# UNITED STATES PATENT AND TRADEMARK OFFICE

10/735,440

<b>Office Action Summary</b>	Application No.	Applicant(s)	
	10/735,440	KOLLMANN ET AL.	
	Examiner	Art Unit	
	Charles E. Phillips	3751

SN 10/735,440  
Substitute Drawing

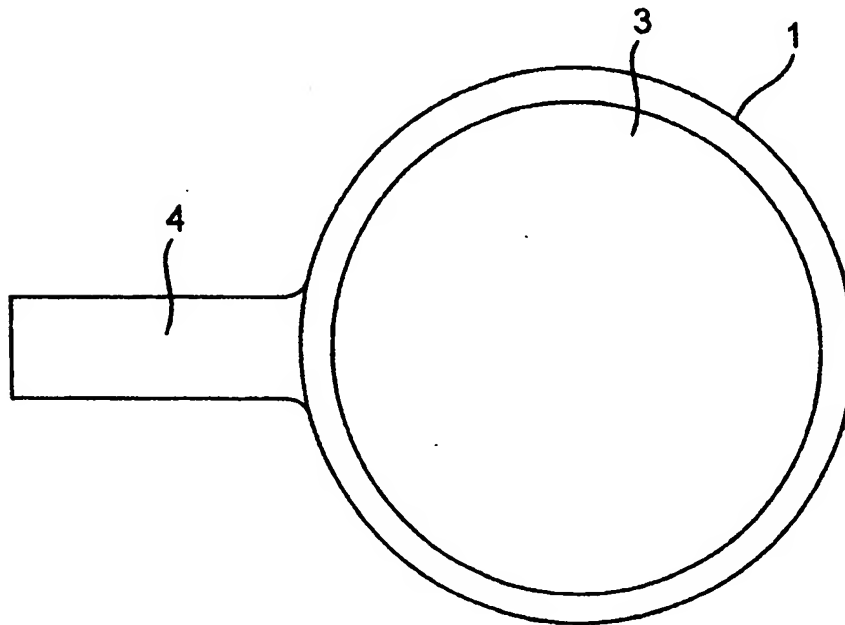
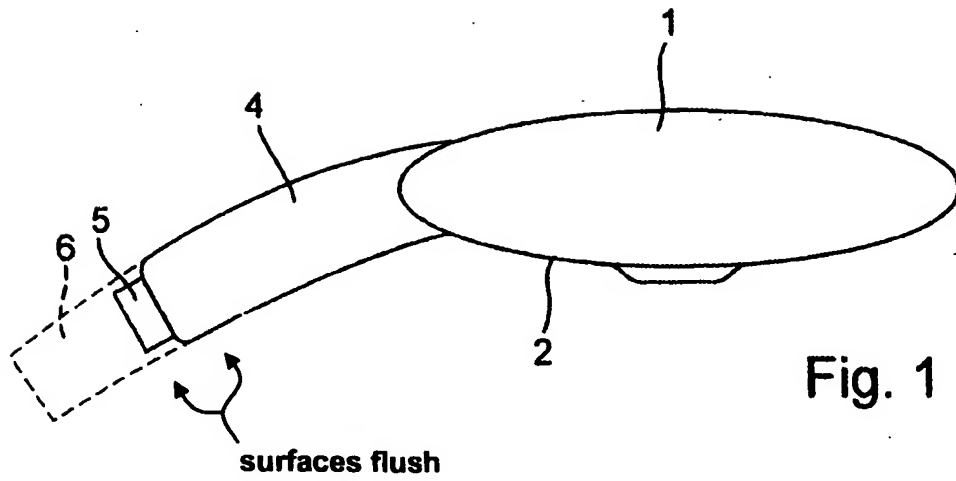
The proposed drawing correction filed on 9/28/07 is disapproved as the depiction of the union nut is inconsistent with that of the original drawings in that the double lines at the hose end are lacking, the fitting is of a different shape and the terminal end of the handle is rounded.

The drawings are objected to as being informal and for the use of a broken line showing of substance being claimed, i.e. under 37 C.F.R. 1.84(a)(4) broken lines are reserved for "alternate views". Corrected drawing sheets in compliance with 37 CFR 1.121(d) are required in reply to the Office action to avoid abandonment of the application. Any amended replacement drawing sheet should include all of the figures appearing on the immediate prior version of the sheet, even if only one figure is being

not approved  
11/9/07 CEP
